From: Christian Araguas
Sent: Wednesday, November 12, 2008 3:18 PM
To: jtdavis@southernco.com
Cc: wasparkm@southernco.com; agaughtm@southernco.com; crpierce@southernco.com
Subject: Advanced Safety Evaluation Report on the VEGP ESP and LWA Part 3b/3
Attachments: Vogtle ESP Advanced SER Chapter 2.5.2 - 2.5.6.pdf

2.5.2 Vibratory Ground Motion

Figure 2.5.2-11 - Histogram showing magnitudes of the 30 earthquakes that had M 6.5 and larger in the world's extended margins (Source: USGS)

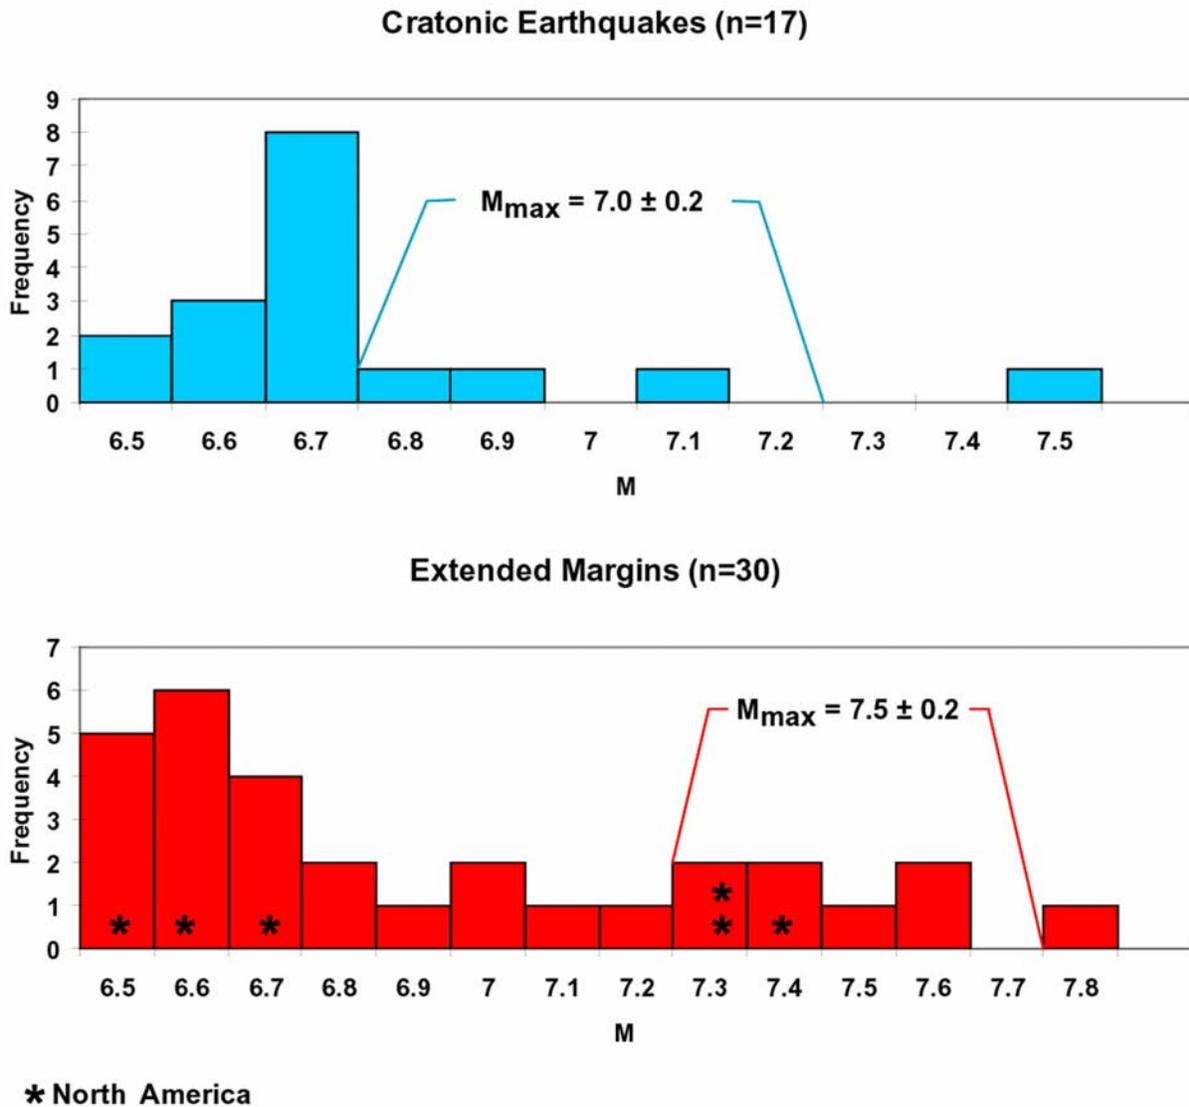
In response to RAI 2.5.2-6, the applicant also stated that the Vogtle ESP site is located within Kanter's (1994) Piedmont domain 223 in nonextended crust and, as a result, large magnitude earthquakes are not expected in this domain. The staff, however, believes that the ESP site is located within the Mesozoic passive margin. Specifically, the site is on the hanging wall of the southeast-dipping Pen Branch fault (SSAR Figures 2.5.1-2, 2.5.1-29, and 2.5.1-34), which is the main border fault of the Dunbarton Triassic basin (SSAR Figures 2.5.1-2 and 2.5.1-10). In turn, the Dunbarton Triassic basin is a subbasin within the much larger South Georgia basin complex (SSAR Figures 2.5.1-2 and 2.5.1-7). Therefore, the site is in Kanter's Eastern Seaboard domain 218. The rocks beneath the site are Triassic strata of domain 218's rift basins (SSAR Figures 2.5.1-34 and 2.5.1-38). Beneath the Triassic rocks is the Piedmont domain, but the Piedmont rocks have been cut by the Mesozoic extensional faults that bound the rifts. The distinction between the Eastern Seaboard and Piedmont domains depends on the presence or absence of Mesozoic extensional faults, rather than the age of the rocks cut by those faults. Accordingly, the staff believes that the site is subject to the higher Mmax of the Eastern Seaboard domain of Kanter (1994). The site is in one of the regions that Johnston et al. (1994) found to have hosted all earthquakes of **M** 7.0 and larger in the world's stable continental regions (SCRs).

SER Figure 2.5.2-11 shows a histogram of magnitudes of the 30 earthquakes that had **M** 6.5 and larger in the world's extended margin, which is based on the compilation of the largest earthquakes in the world's SCRs by Johnston et al. (1994). The histogram has a large peak at **M** 6.6 and 6.7. The earthquakes making up the peak come from various SCRs, continents, and plate tectonic settings, indicating that values of 6.6 and 6.7 occur widely in diverse geologic and tectonic settings. This implies that Mmax is unlikely to be less than these values anywhere in the extended margin of North America. As such, the low weights and low probability of activities assigned by the Dames and Moore EST to larger Mmax values do not reflect worldwide earthquake activity in extended margins.

In summary, the staff concluded that the applicant did not provide an adequate justification to support the low weights for the larger M_{max} values for the EPRI source zones that include the site. In particular, the staff was concerned that the low weights and low probability of activities assigned by the Dames and Moore EST to some of its seismic source zones result in hazard curves for the ESP site that may not adequately characterize the regional seismic hazard. In addition, the staff concluded that the site is located within the Mesozoic passive margin, rather than the Piedmont unextended province as stated in the applicant's response. Accordingly, in the SER with open items, this issue was identified as Open Item 2.5-1.

Figure 2.5.2-12 - Comparison of the staff's 1-Hz hazard curves for the ETSZ for magnitudes ranging from M 6.0 to M 7.8

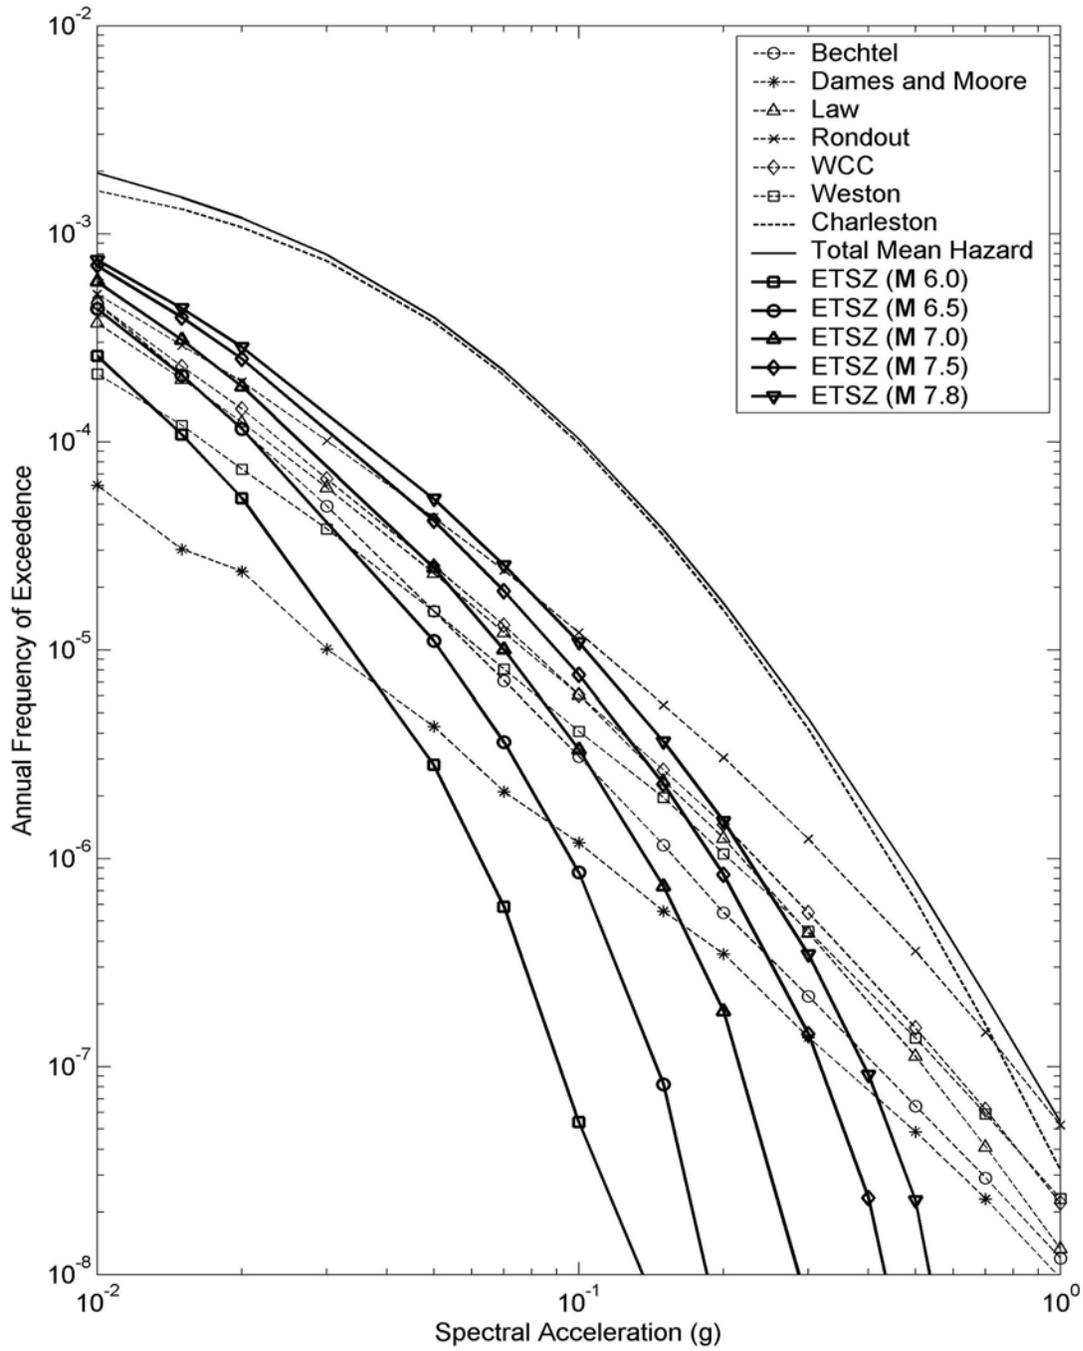
calculations using maximum magnitudes for the ETSZ that ranged from **M** 6.0 to **M** 7.8. This magnitude range reflects more recent M_{max} values assigned to the ETSZ, as shown in SER Table 2.2.5-6. SER Figure 2.5.2-12 shows the staff's 1-Hz hazard curves for the ETSZ using this range of M_{max} values. SER Figure 2.5.2-12 also shows the applicant's total mean hazard curve and the Charleston seismic source zone contribution for comparison. The staff's results show that, although the Charleston seismic source zone clearly dominates the 1-Hz hazard, the contribution from the ETSZ for some of the larger M_{max} values (greater than 7.0) may contribute significantly more than 1 percent to the total hazard for the ESP site.

The staff concluded that, despite the uncertainty regarding the potential for large earthquakes within the ETSZ, the results of post-EPRI source characterizations for the ETSZ suggest that the EPRI EST characterization of the ETSZ needs to be updated. The results of the staff's confirmatory analysis confirmed the applicant's assertion that the Charleston seismic source dominates the 1-Hz hazard. However, the staff concluded in the SER with open items that the contribution of the ETSZ at the ESP site may be significant enough to warrant inclusion in the applicant's PSHA, if larger Mmax values are considered. Accordingly, in the SER with open items, this issue was identified as Open Item 2.5-3.

Figure 2.5.2-13. Composite EPRI-SOG distribution in terms of M compared to more recent assessments (reproduced from the Bellefonte RCOL application)

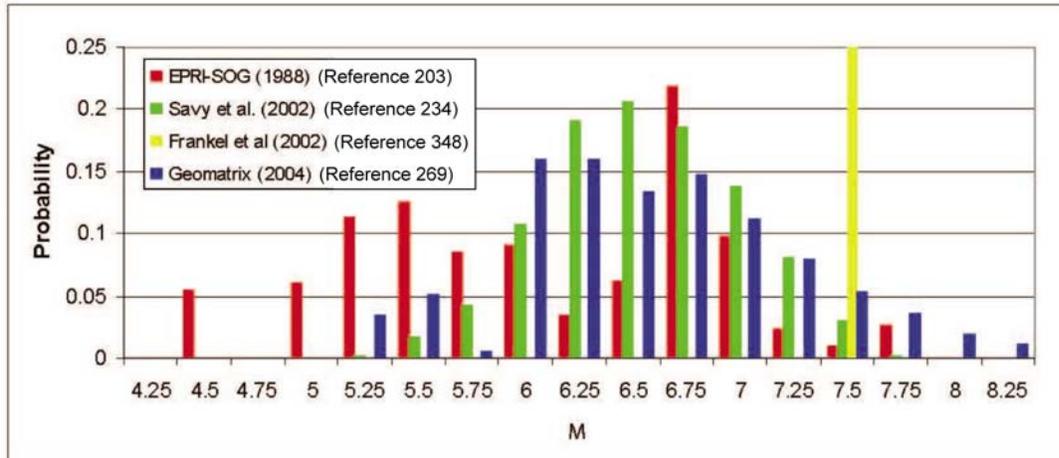
The staff disagrees with the applicant's conclusions that additional calculations of seismic hazard with larger Mmax for the ETSZ are not warranted. The staff notes that there are more recent seismic hazard studies, such as the LLNL TIP study and the Geomatrix TVA Dam safety study, which provide new information on the seismic hazard of the area. Furthermore, the staff does not agree with the applicant's conclusion that the EPRI team's Mmax composite distribution for the ESTZ is similar to that of more recent studies. The applicant only compared the range of the Mmax values of the EPRI study rather than the actual weighted values. SER Figure 2.5.2-13 clearly shows that more recent studies place a significantly higher probability on larger maximum magnitude earthquakes than the EPRI study. The mean Mmax for the TIP (i.e. Savy et al., 2002) and Geomatrix studies are approximately **M6.55** and **M6.58**, respectively.

The staff concludes, however, that the contribution of the ESTZ at the Vogtle ESP site is insignificant, even when Mmax values comparable to the mean Mmax values for the TIP and Geomatrix studies are considered. Based on the staff's sensitivity study, presented in SER Figure 2.5.2-12, a mean magnitude of **M6.5** for the ETSZ contributes to less than 1 percent of the total hazard at 1 Hz for ground motions critical for design levels (0.1 g and higher). Therefore, the staff considers Open Item 2.5-3 to be resolved.

Figure 2.5.2-14 – Geographic Distribution of Liquefaction Features Associated with Charleston Earthquakes (SSAR Figure 2.5.2-12a)

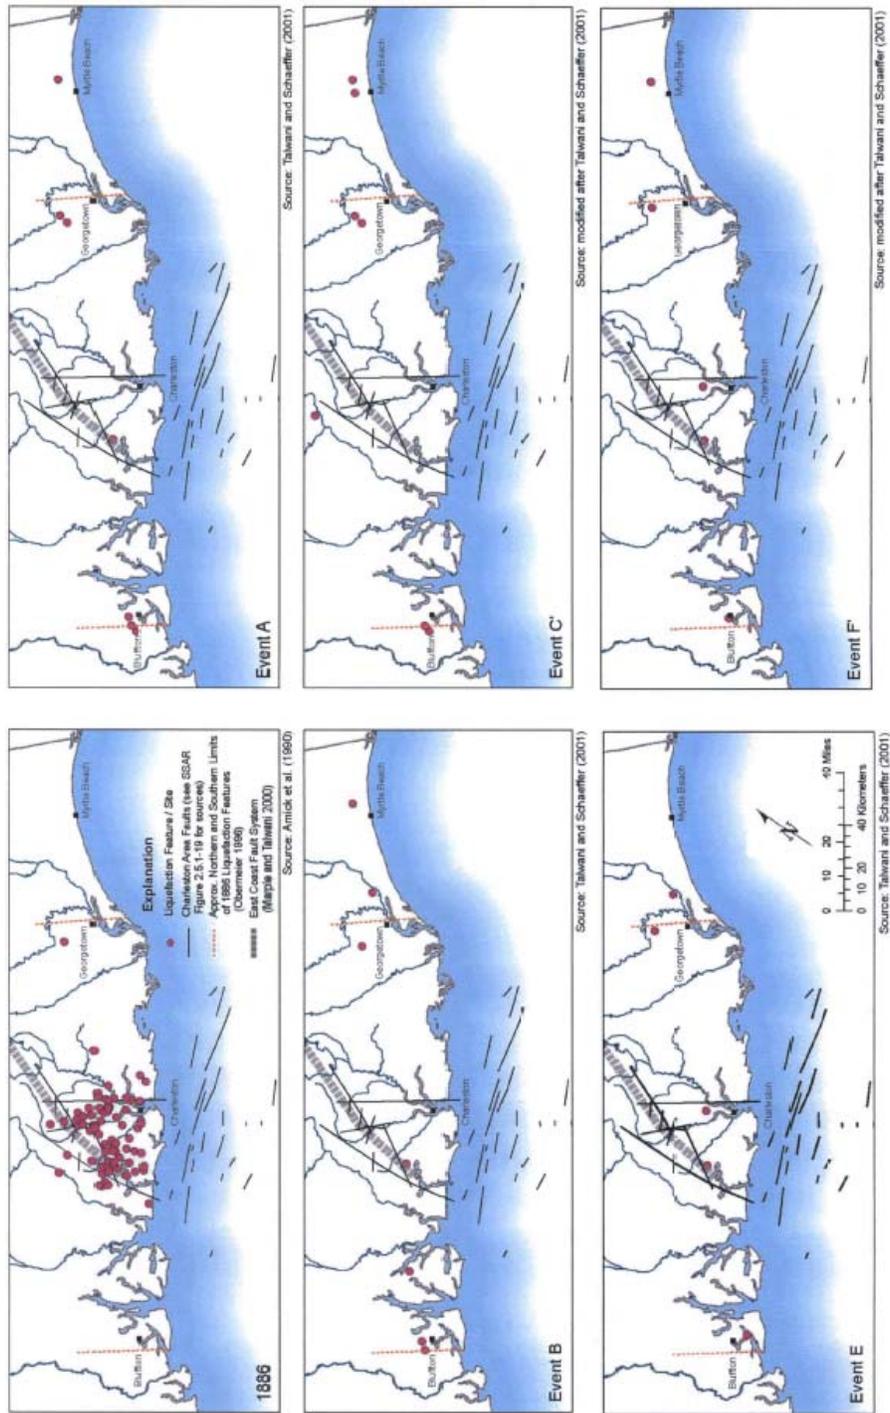
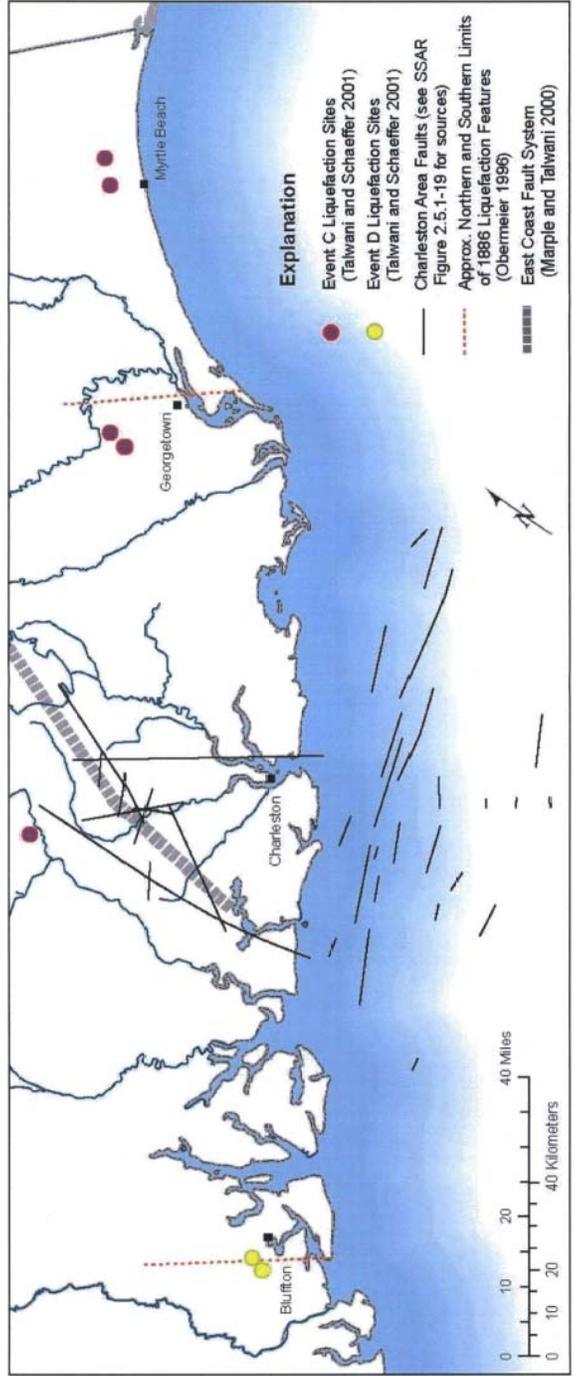
The applicant provided a visual depiction of this information (SER Figure 2.5.2-14) to allow a comparison of liquefaction features associated with Talwani and Schaeffer (2001) events C and D to determine any overlap that could provide further evidence that these two events should be combined into a single event, C'. The applicant stated that liquefaction features associated with events C and D are localized and do not show any spatial overlap and "therefore do not provide definitive geographic evidence for combining these events into a single, large event C'." However, the applicant chose to include a single, large event C' (as opposed to two smaller events C and D) into the updated Charleston seismic source model based on the following three reasons:

3. The distribution of paleoliquefaction sites for Event C' is very similar to the coastal extent of liquefaction features from the 1886 earthquake. Moreover, the distribution and number of paleoliquefaction sites for Event C' are very similar to those for Events A and B, the two best documented prehistoric events (SER Figure 2.5.2-15).

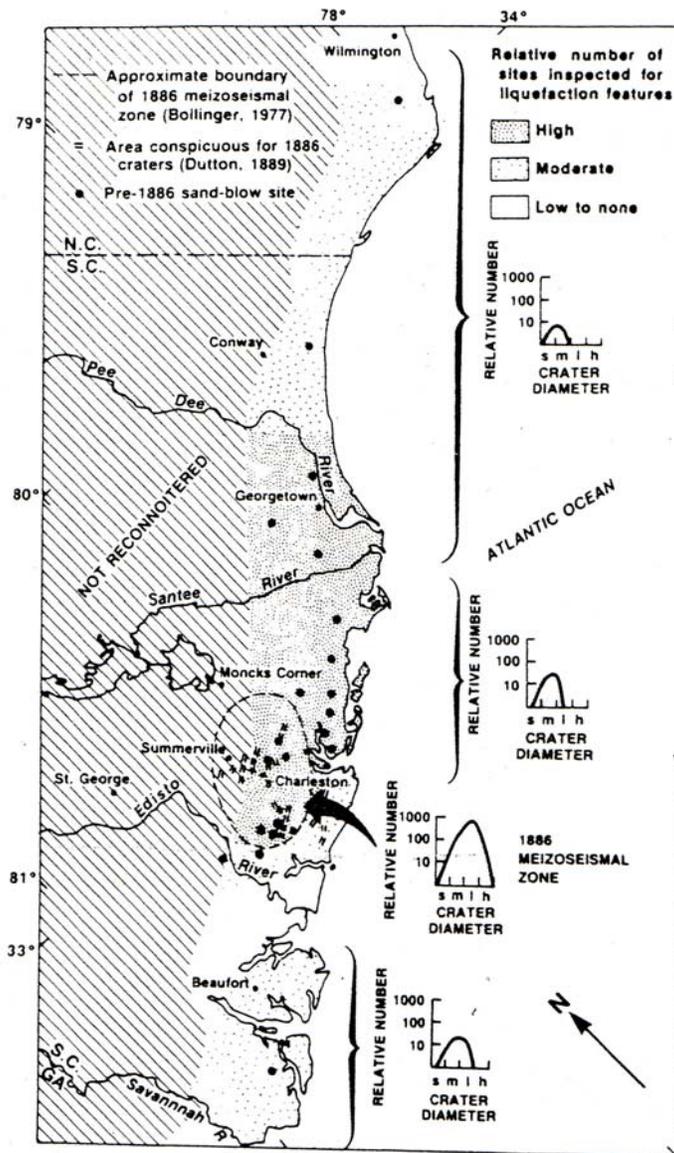
The staff also reviewed the study of Obermeier et al. (1989). Obermeier et al. (1989) conclude that, “Both the size and relative abundance of pre-1886 craters are greater in the vicinity of Charleston (particularly in the 1886 meizoseismal zone) than elsewhere, even though the susceptibility to earthquake-induced liquefaction is approximately the same at many places throughout this coastal region.” Figure 4 of Obermeier et al. (1989), reproduced as SER Figure 2.5.2-16, depicts the sizes of various prehistoric liquefaction features and demonstrates that the largest craters of all ages concentrate near Charleston. The staff notes that the figure cannot exclude the possibility that one (or more) of the large prehistoric earthquakes created its (or their) largest liquefaction features elsewhere. However, Obermeier’s (1989) figure shows four size classes of craters, with the largest prehistoric craters (wider than 3 meters) present only in the 1886 meizoseismal area. Only smaller craters are known farther south and north. Obermeier (1989) favors attributing some of these distant, small-to-medium-sized craters to infrequent moderate earthquakes at two separate sources far north and south of Charleston. The epicentral regions of 1886-sized earthquakes should have abundant craters wider than 3 meters, and they have been found only near Charleston. Sparse exposures preclude saying much about crater sizes between Beaufort and the Edisto River, south of Charleston (Obermeier et al. 1989) and south of Geometry A. Thus, it is unlikely, but possible, that the paleoliquefaction record of a large earthquake’s meizoseismal region could be concealed south of Geometry A. However, this small probability is accounted for by Geometries B and B’, which span most of the length of South Carolina’s coast. The absence of known abundant

Accordingly, the staff concludes that the applicant's use of a small area to represent the sources of the 1886 and all previous large earthquakes is adequate. Available evidence suggests it is likely that 1886-sized earthquakes occurred mostly or entirely within a small area like Geometry A. Evidence provided by the applicant in response to previous Open Item 2.5-5, further supports a localized source contained within Geometry A.

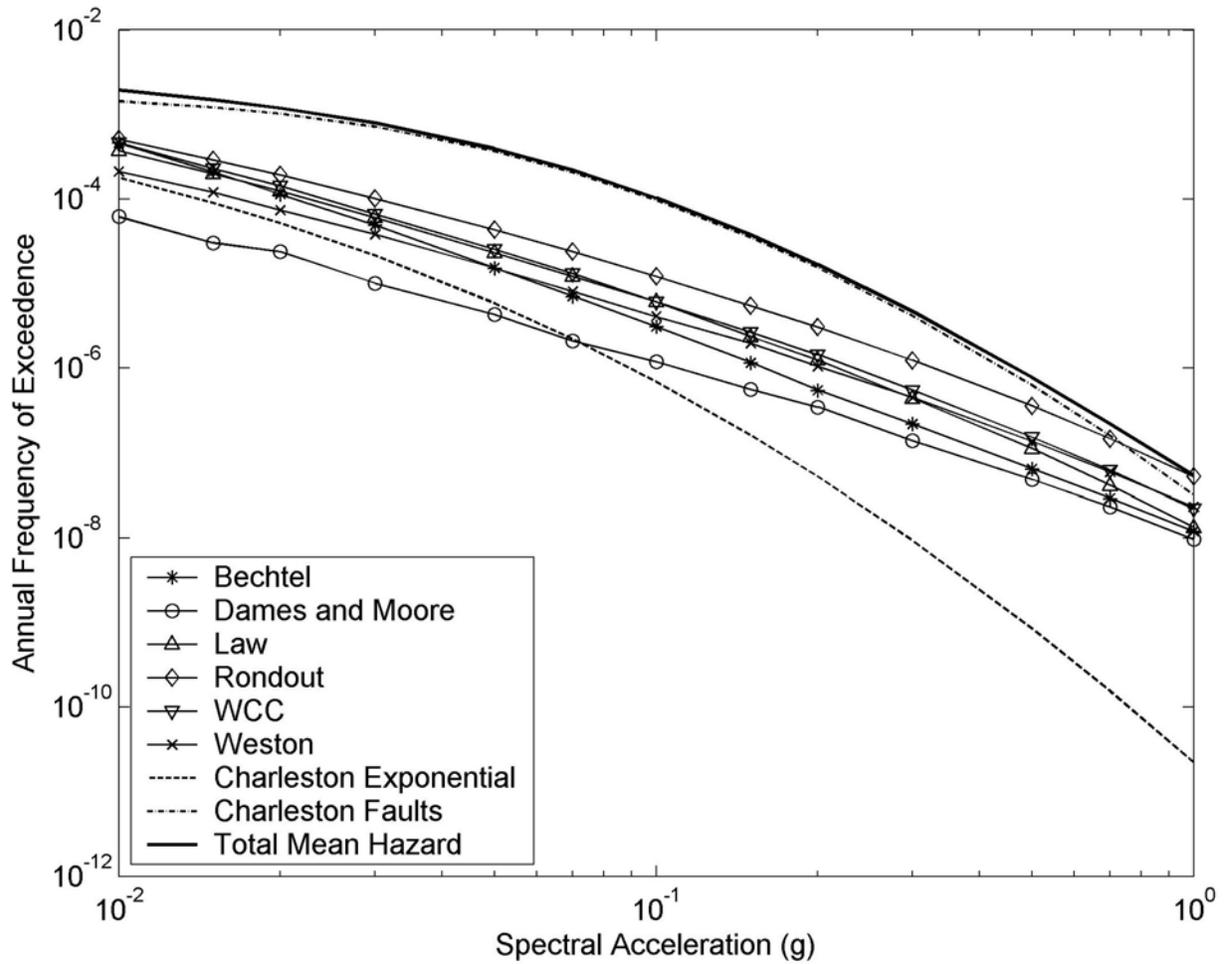
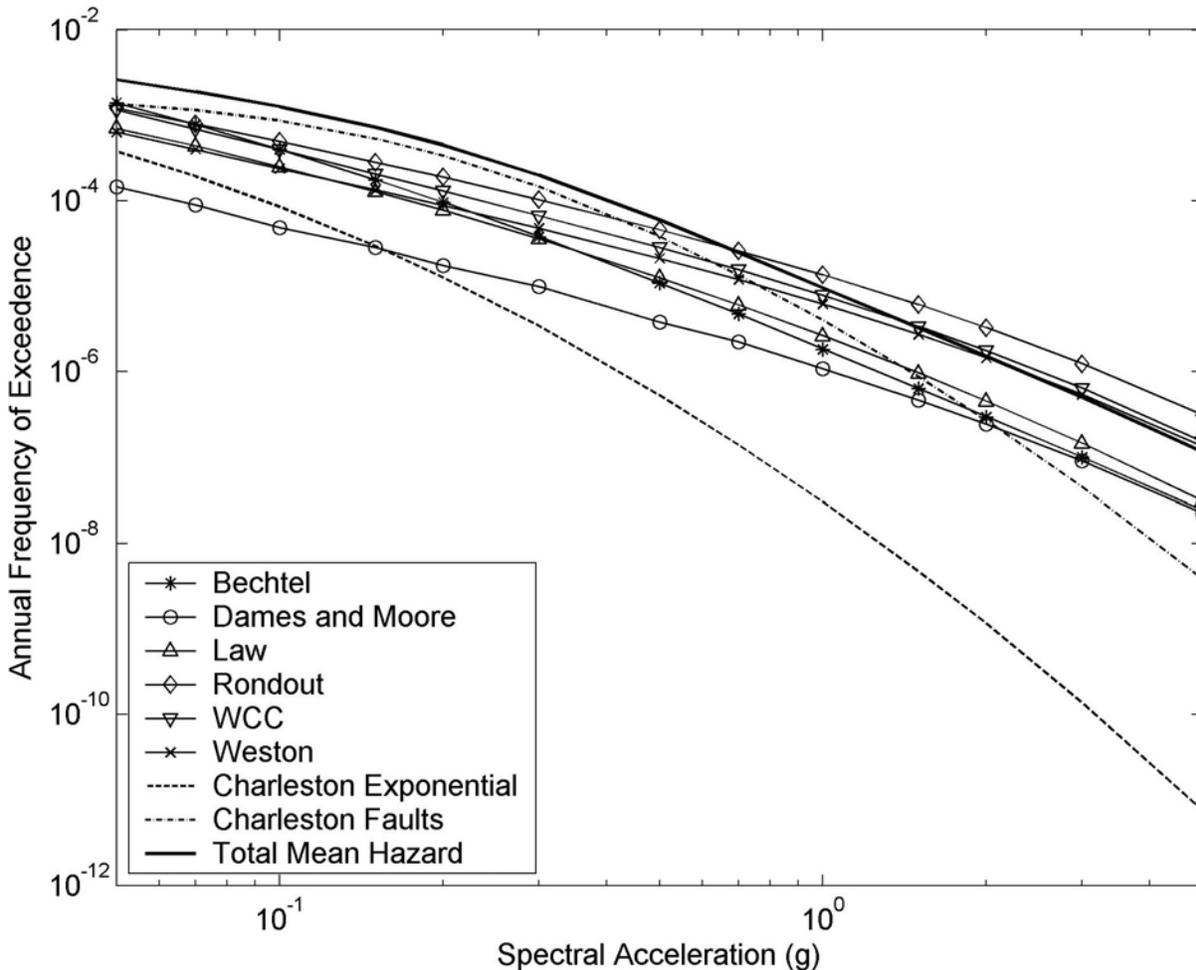
In order to determine the adequacy of the PSHA results, the staff, in RAI 2.5.2-1, requested that the applicant to provide the 1- and 10-Hz mean hazard curves for each of the six EPRI ESTs, as well as the 1- and 10-Hz mean hazard curves for the UCSS model. In response to RAI 2.5.2-1, the applicant provided the requested hazard curves. SER Figures 2.5.2-17 and 2.5.2-18 show the applicant's 1-Hz and 10-Hz total mean hazard curves, as well as the hazard curves corresponding to each of the six EPRI EST seismic source model inputs. Both figures also show the hazard curves corresponding to the applicant's UCSS model.

As shown in SER Figure 2.5.2-17, for the 1-Hz hazard curves, the Charleston source dominates the overall hazard at the ESP site. In SER Figure 2.5.2-18, for the 10-Hz hazard curves, the contributions from each of the six ERPI seismic source models have a more significant contribution to the overall hazard.
